PLANNING COMMISSION MEETING

A. **Oakland Harvesters**
Location: located on the north side of White Lake Road, west of Old White Lake Road. Identified as parcel 12-01-127-001, consisting of 2 acres. Currently zoned (LM) Light Manufacturing.
Request: **Final site plan approval**
Applicant: Oakland Harvesters
840 Sherbrooke St
Commerce Township, MI 48382

RE: Oakland Weed Harvesters -Final Site Plan Review- 1st Review

RE: Oakland Harvesters
Final site plan – Review #1

DRAWING TITLE:
**Landscape
Details**

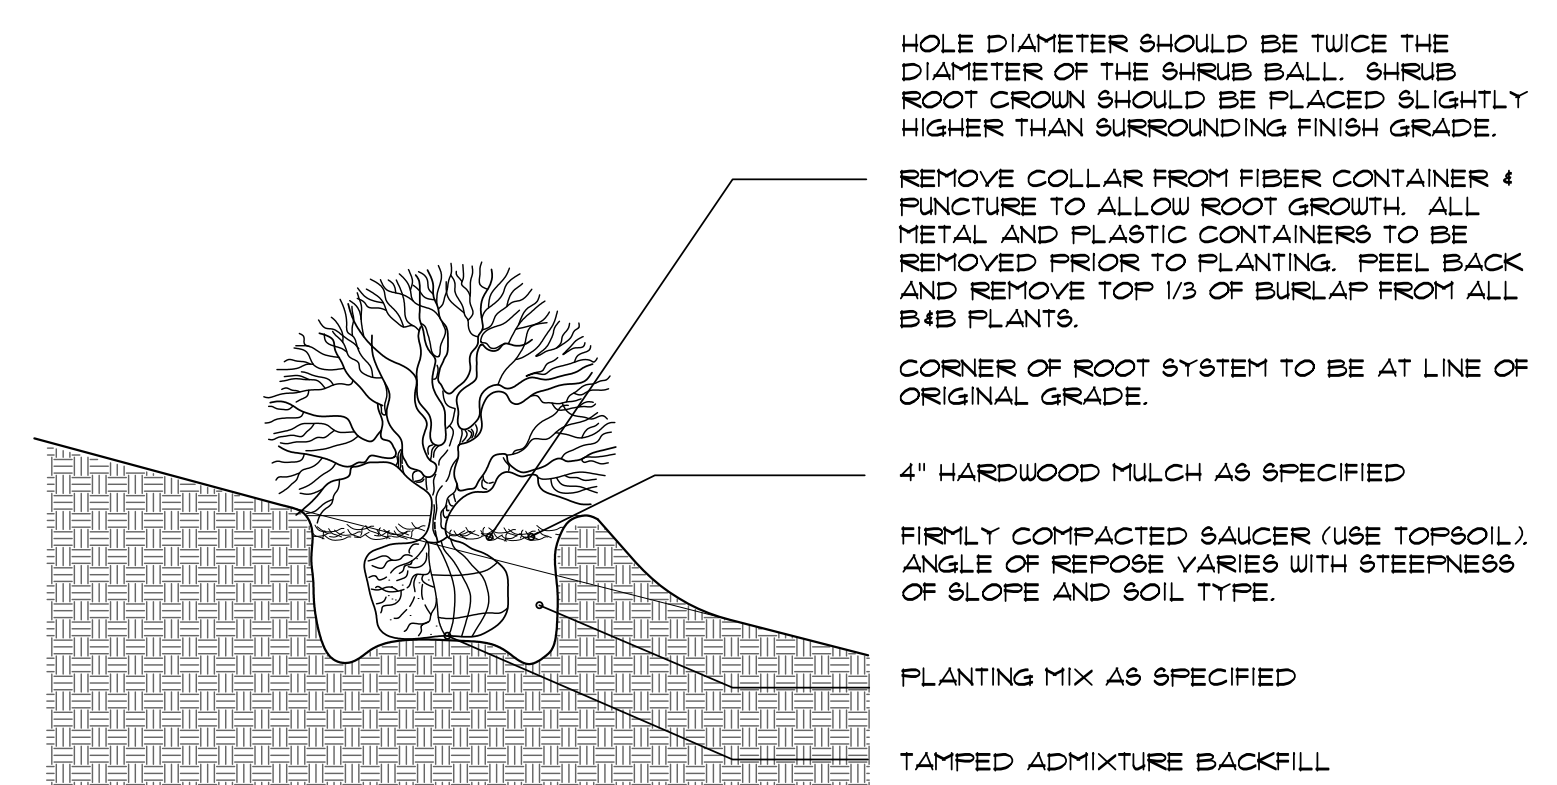
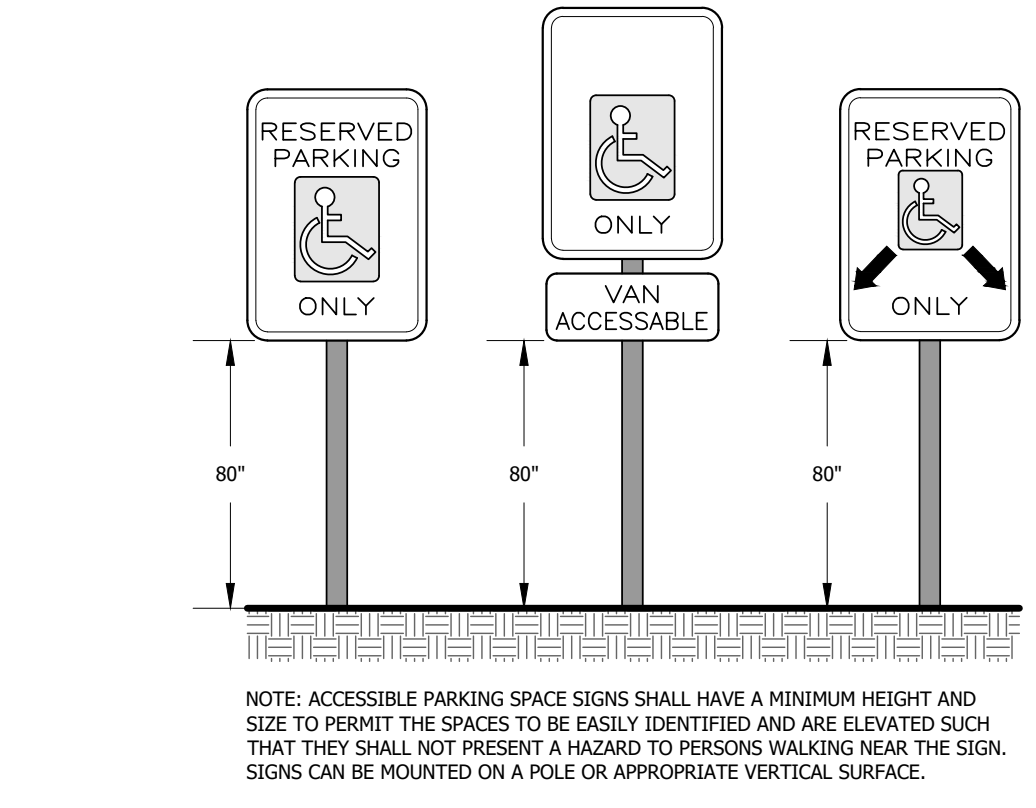
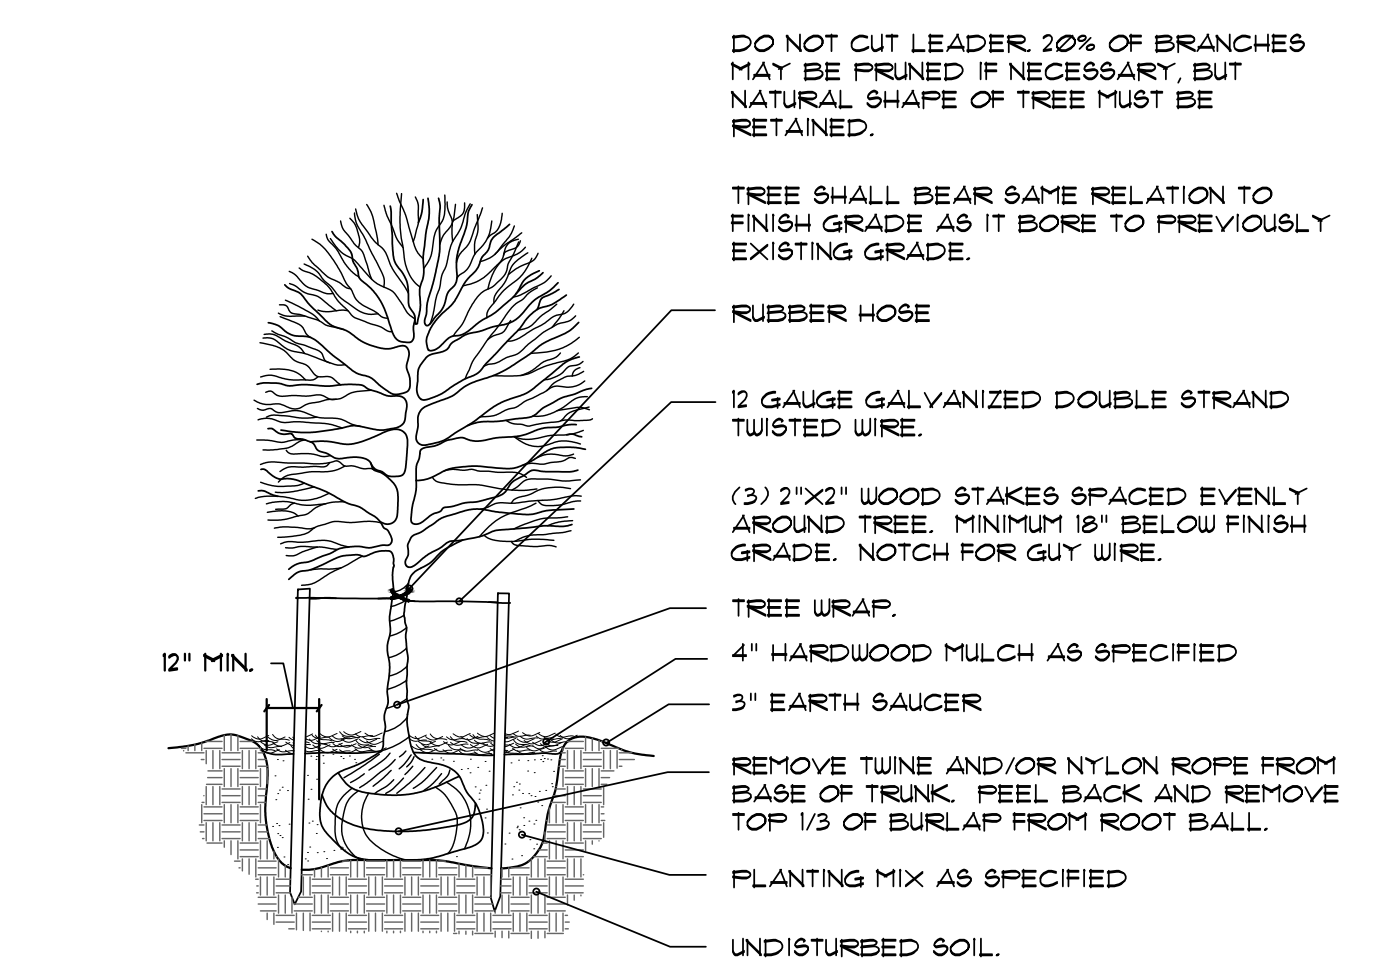
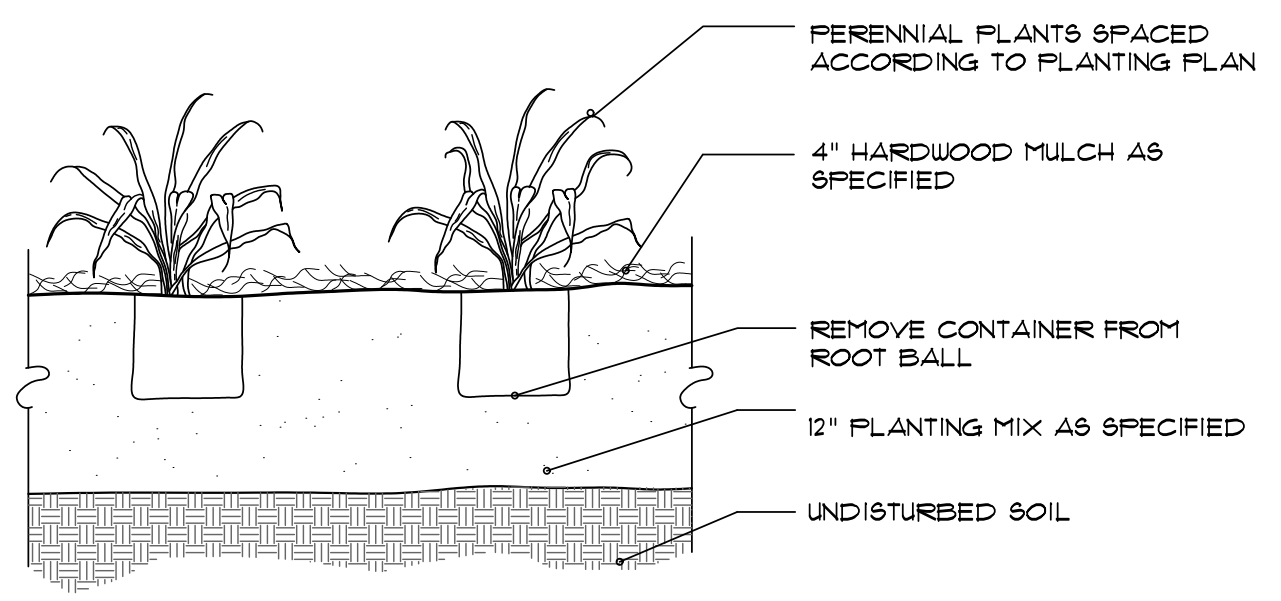
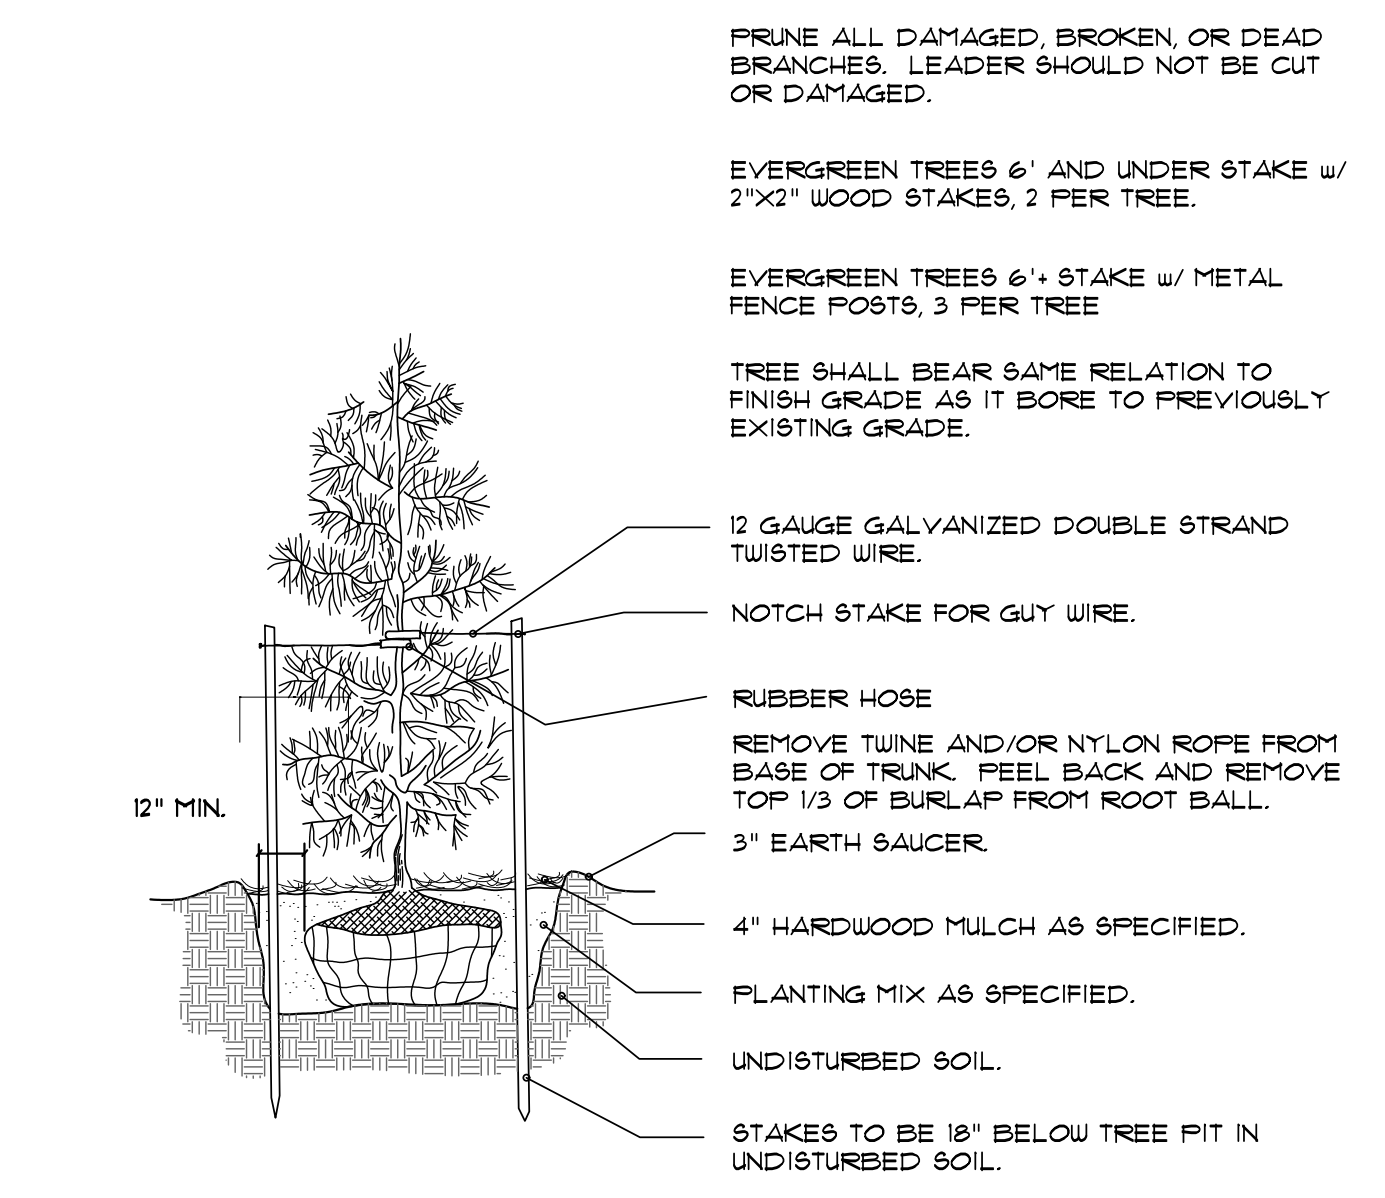
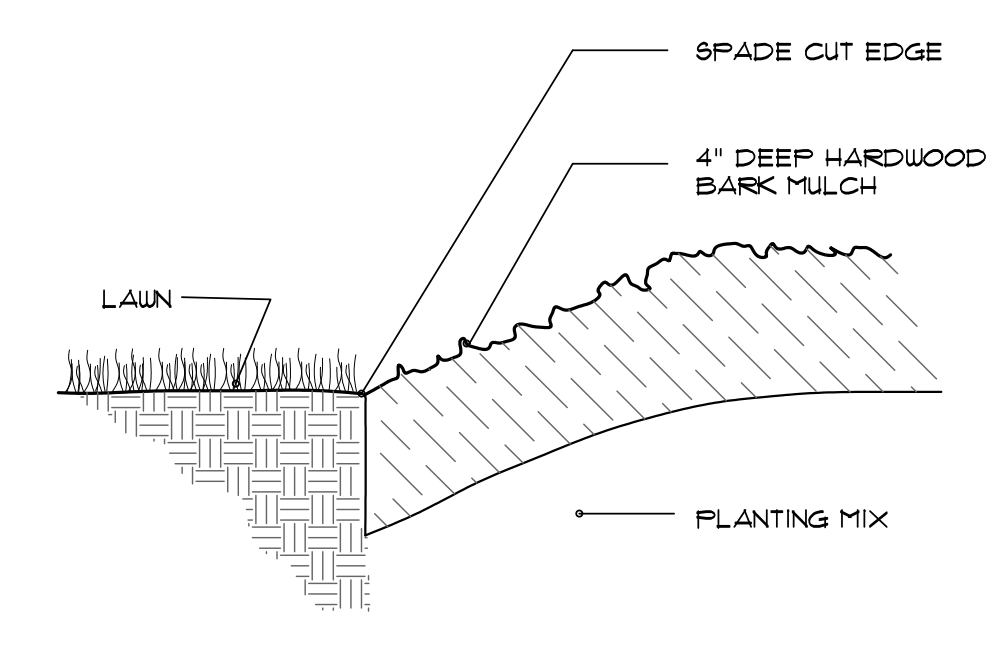
- **Sheet L-2 (Landscape Details) references the Pontiac Landscape Ordinance. Revise accordingly.**
